STAFF RECOMMENDATION 1415 McKennie Avenue July 20, 2016

Application: Demolition; New construction—outbuilding; Setback determination
District: Eastwood Neighborhood Conservation Zoning Overlay
Council District: 06
Map and Parcel Number: 08302000900
Applicant: Lynn Taylor
Project Lead: Melissa.sajid@nashville.gov

Description of Project: Application is to demolish an existing outbuilding and to construct a new outbuilding at the rear of the lot. (It is not proposed to include a detached accessory dwelling unit.) The structure requires a rear setback determination from twenty feet (20') to six feet (6').

Figure 2: 1957 Sanborn map

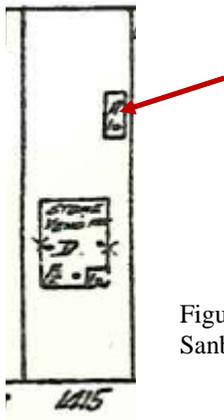
Demolition is proposed for the existing non-contributing outbuilding. The Sanborn maps show an outbuilding on the property in 1957; that outbuilding, however, was smaller and located closer to the right property line than the outbuilding to be demolished which is situated closer to the rear of the site, near the left property line (Figures 2 & 3). Staff therefore finds that the structure does not contribute to the architectural and historical character and significance of the district, and that its demolition meets Section III.B.2 for appropriate demolition and does not meet section III.B.1 for inappropriate demolition.

FIRST FLOOR PLAN

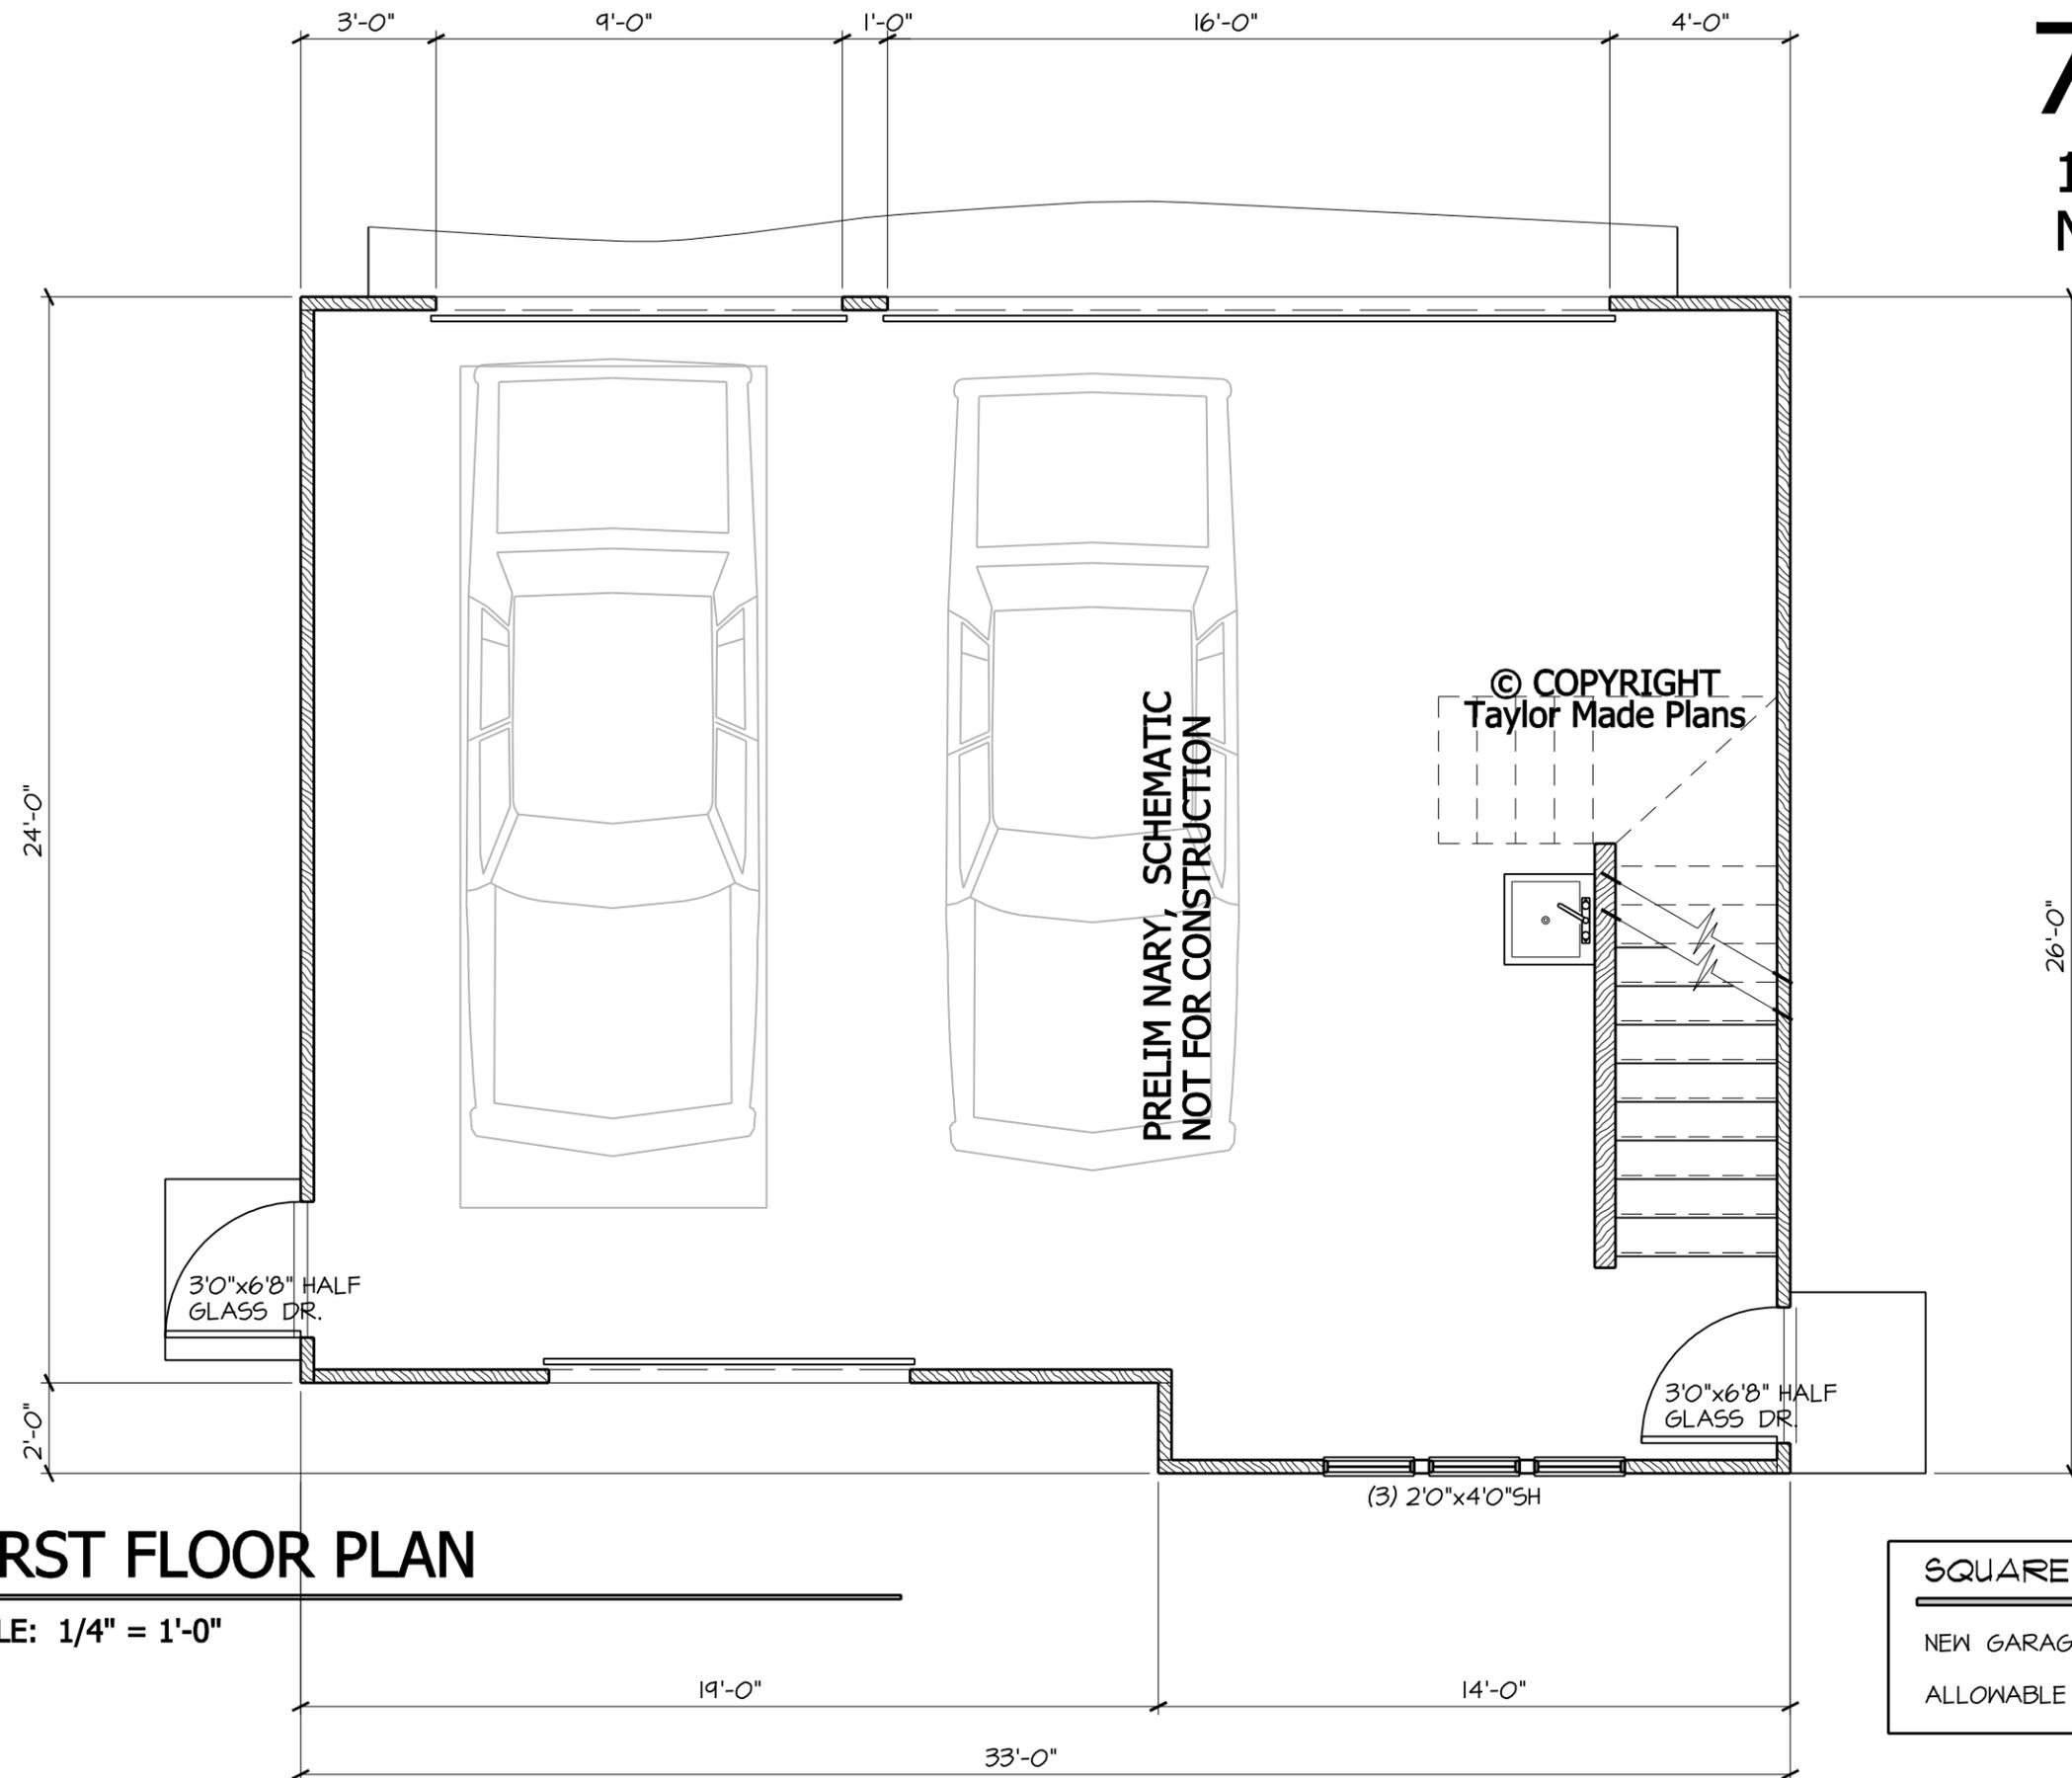
The outbuilding also exceeds the maximum permitted footprint of seven hundred and fifty square feet (750 sq. ft.) by seventy square feet (70 sq. ft.). While the proposed outbuilding does not have to meet the DADU standards, the overage is significant. Staff recommends a condition that the footprint of the outbuilding not exceed the maximum of seven hundred and fifty square feet (750 sq. ft.) to ensure that the outbuilding is appropriately scaled for the site. With this condition, staff finds that the project meets Section II.B.h.1 of the design guidelines.

1. The footprint of the outbuilding shall not exceed seven hundred and fifty square feet (750 sq. ft.); and
2. Staff approve the final details, dimensions and materials of windows, door, garage doors, roof color, and driveway material prior to purchase and installation.
